# ISC-C1 Rack

Title <b>ISC System Wiring Diagram</b>		
Size B	Number <b>D1900511</b>	Revision <b>V8</b>
Date: 8/29/2022	Sheet of 1	38
File: C:\Users\...ISC_C1_SH1.SchDoc	Drawn By: Filiberto Clara

# ISC-R3 Rack

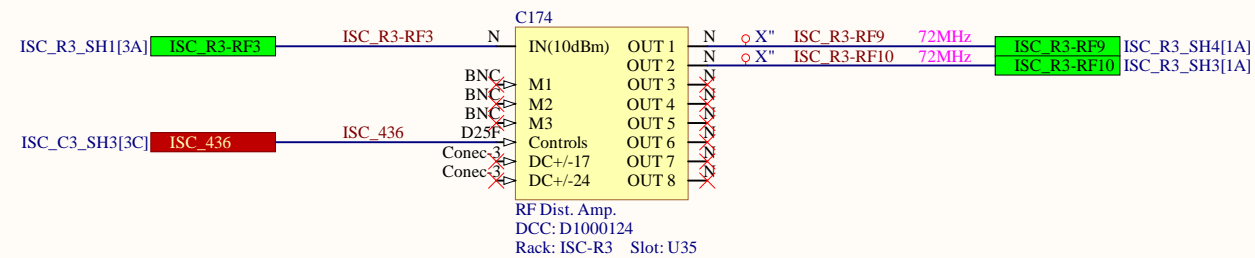
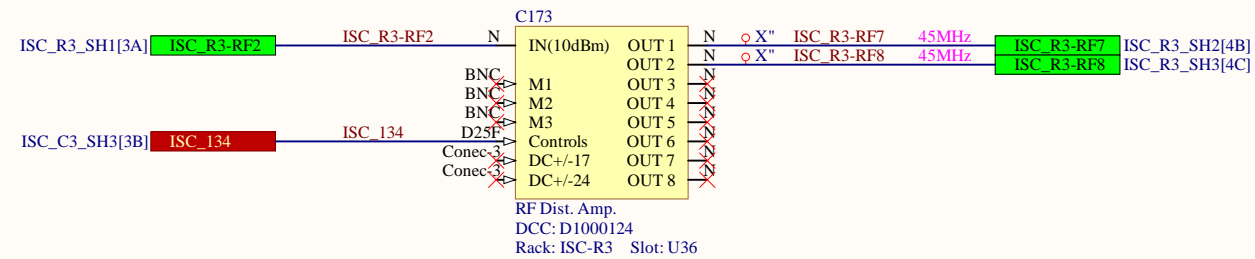
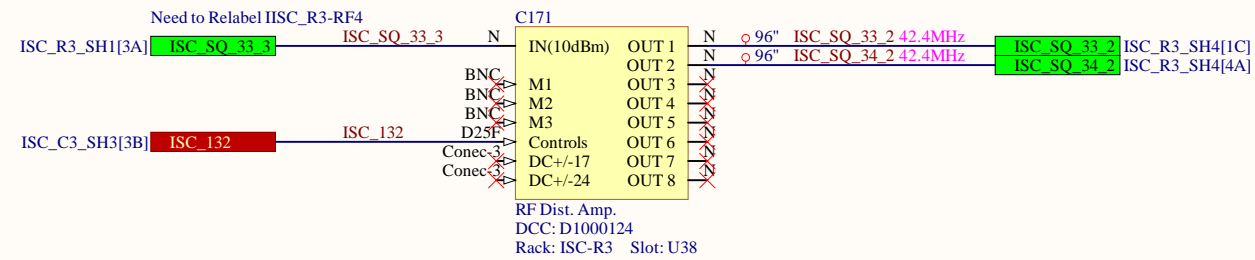
Need to Relabel ISC\_R3-RF4

# ISC-R3 Rack

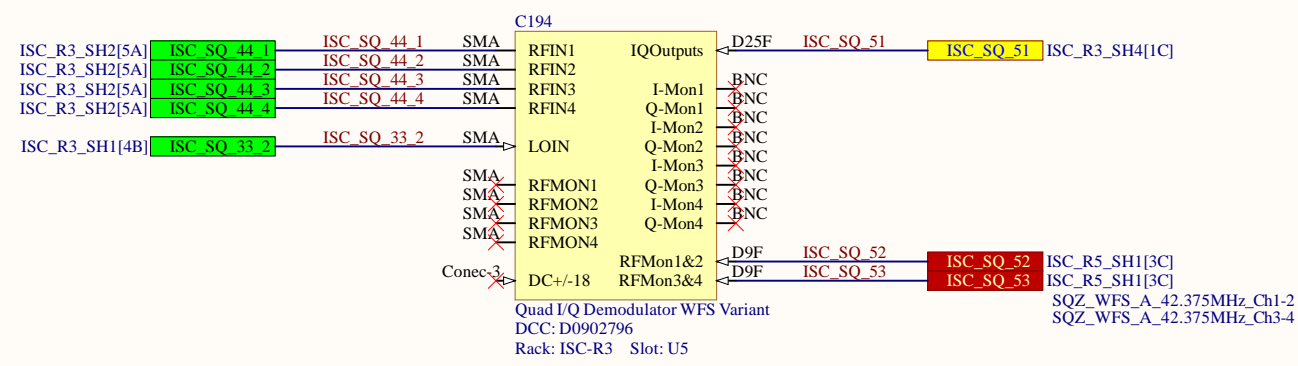
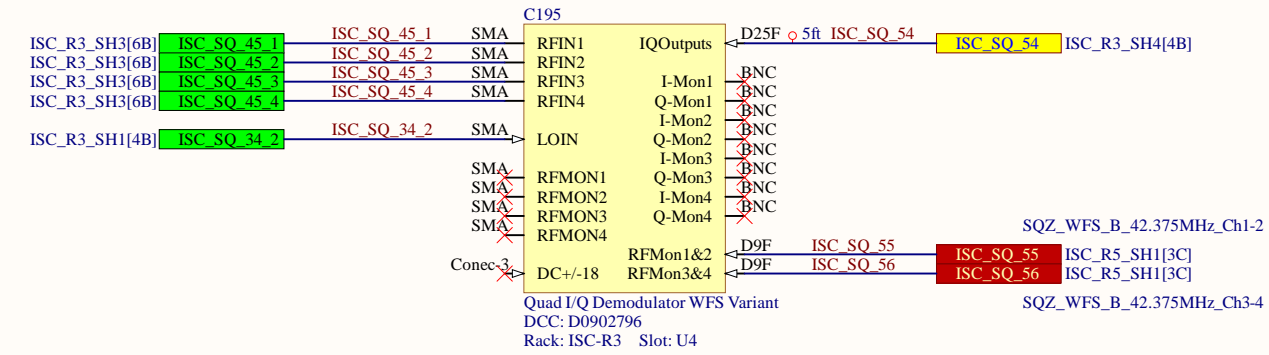
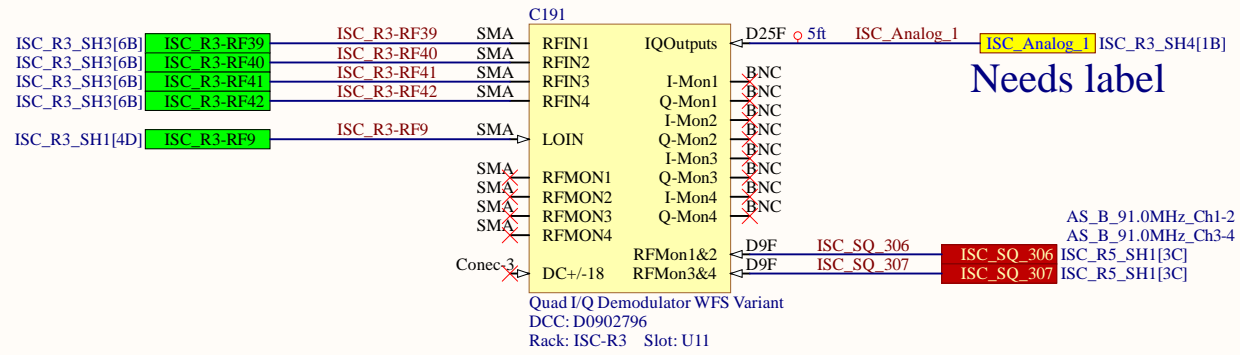
## Needs labels

Needs label

# ISC-R5 Rack

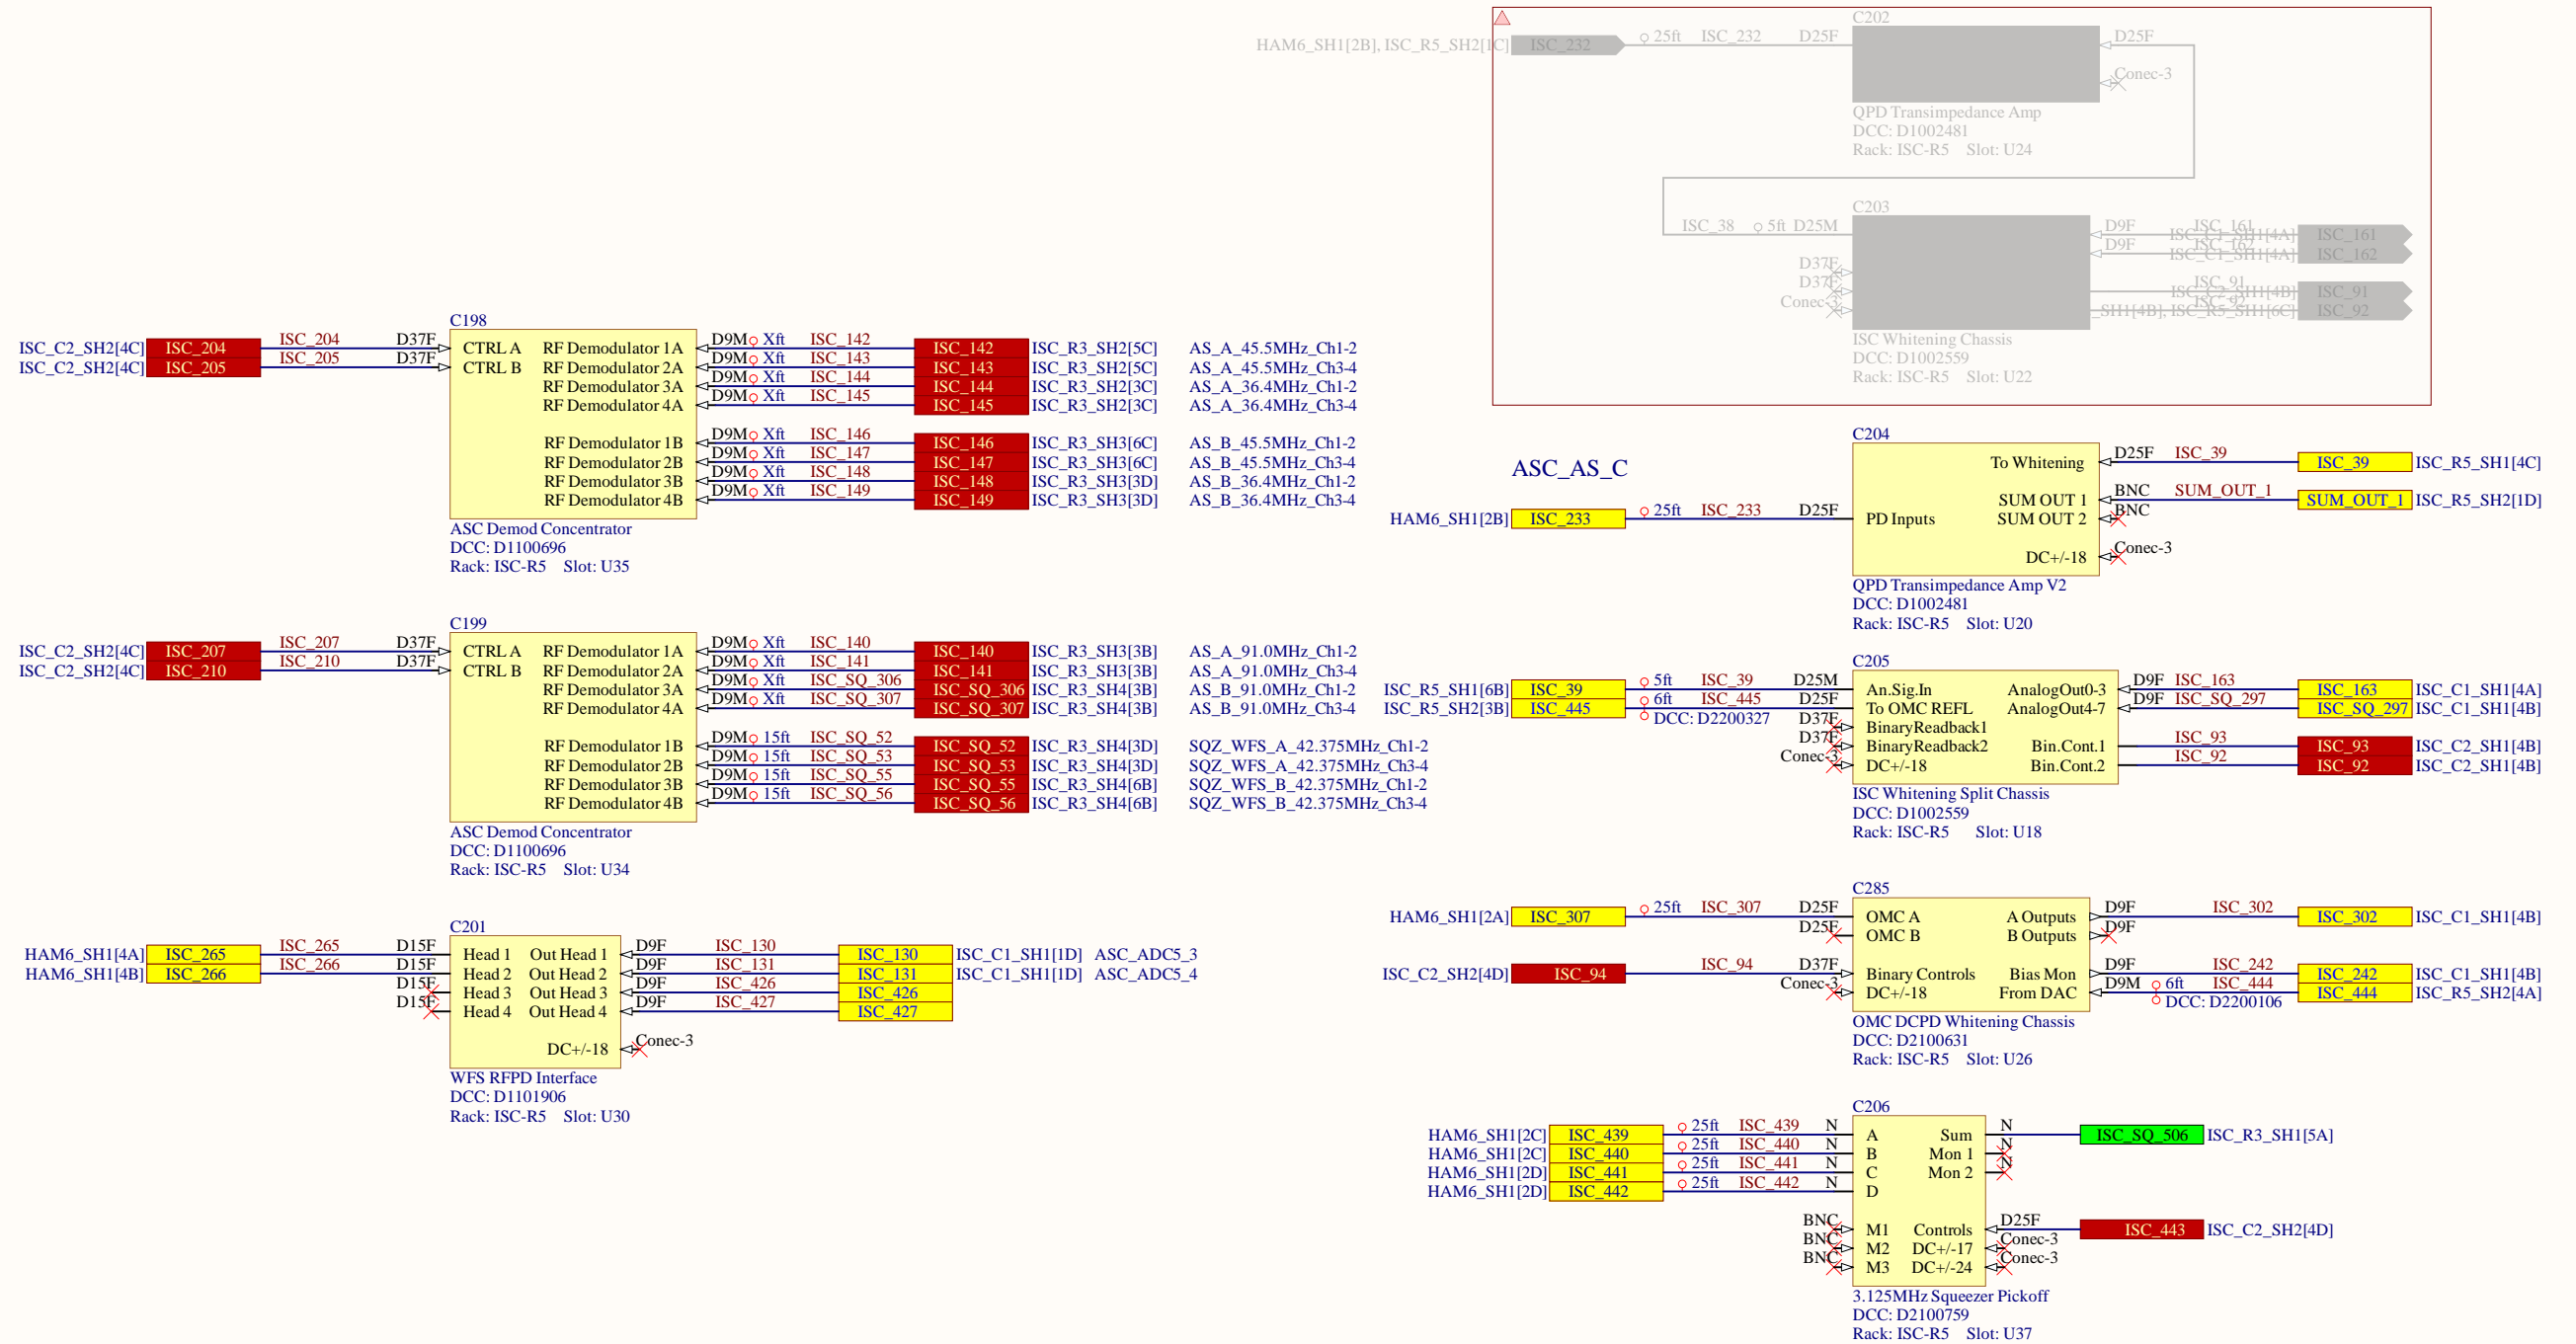
OMCR no longer used at LHO

# IOT2 - Left Side

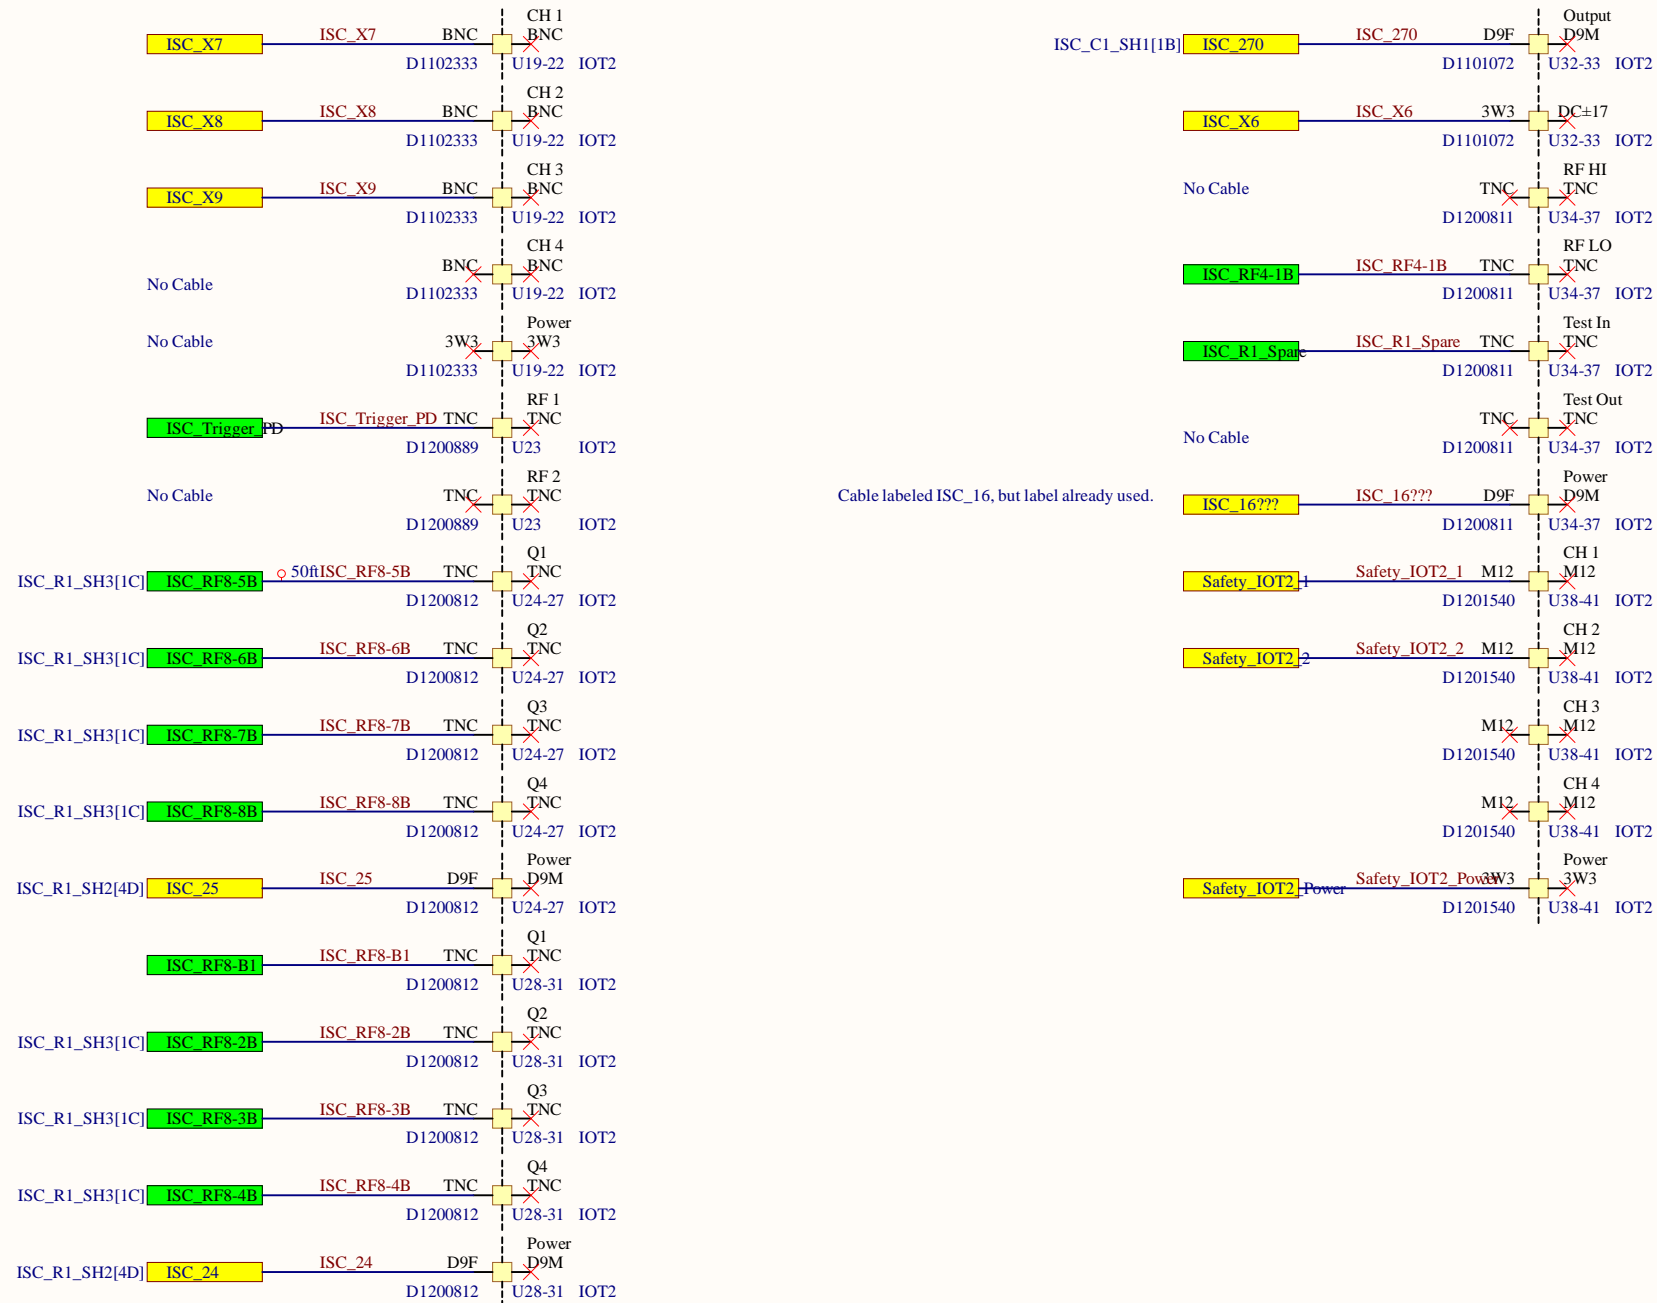
Cable labeled ISC\_16, but label already used.

Title		
<b>Squeezer RF Distribution</b>		
Size	Number	Revision
C	<b>D1900511</b>	<b>V8</b>
Date:	8/29/2022	Sheet of 31 38
File:	C:\Users\...SqueezerRfDistribution.SchDb\Drawn By: R. Abbott

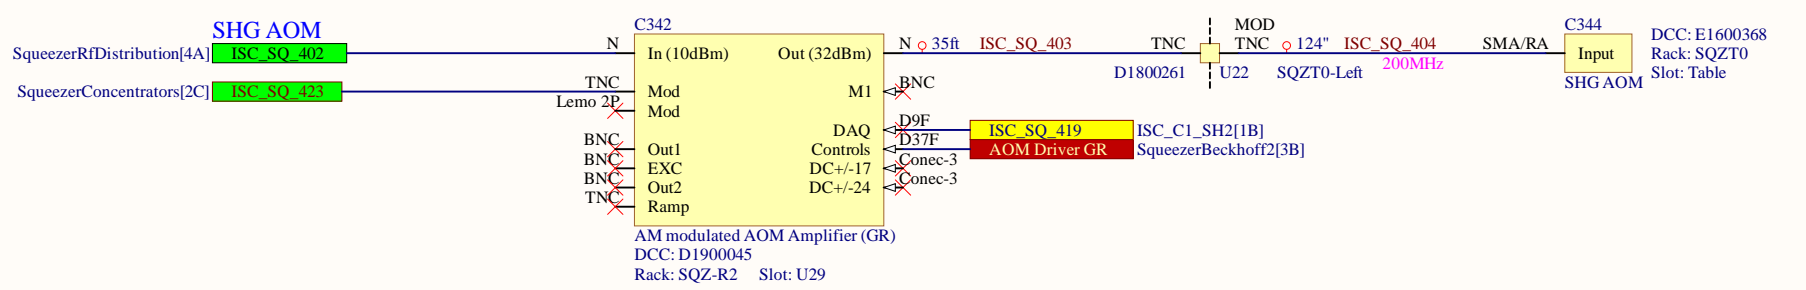
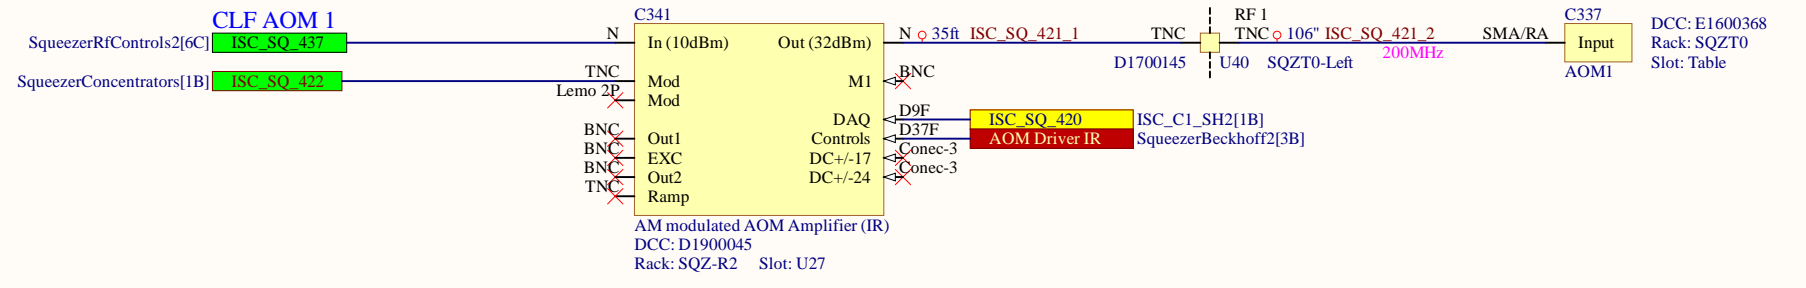
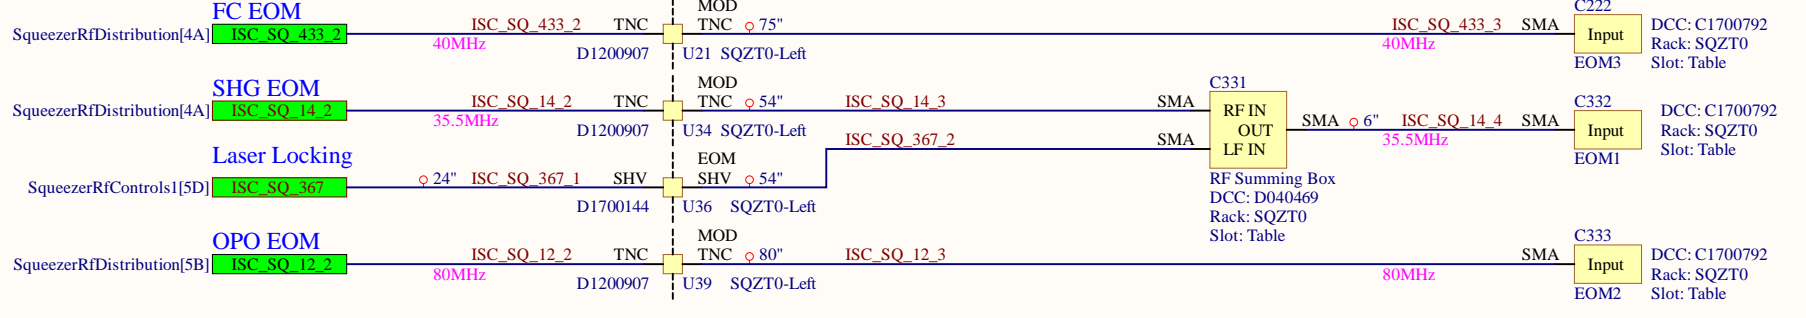
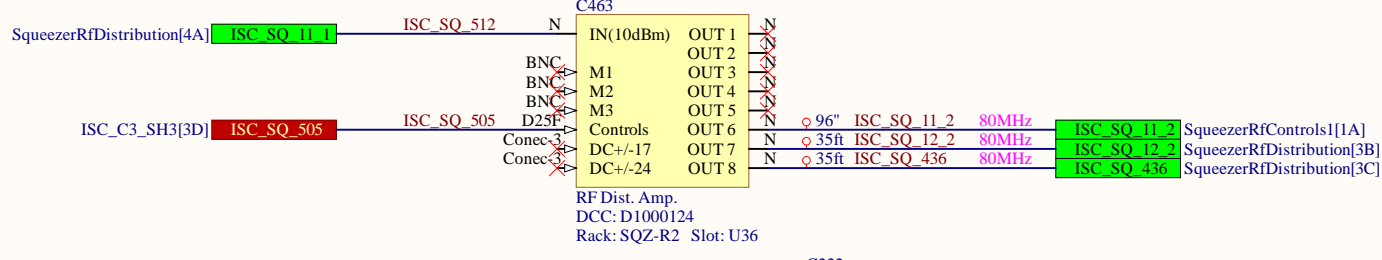
New cables for A\_ start at ISC\_SQ\_430

RF cables carrying the AOM signals need to be 1/4" superflexible helical corrugated coax.
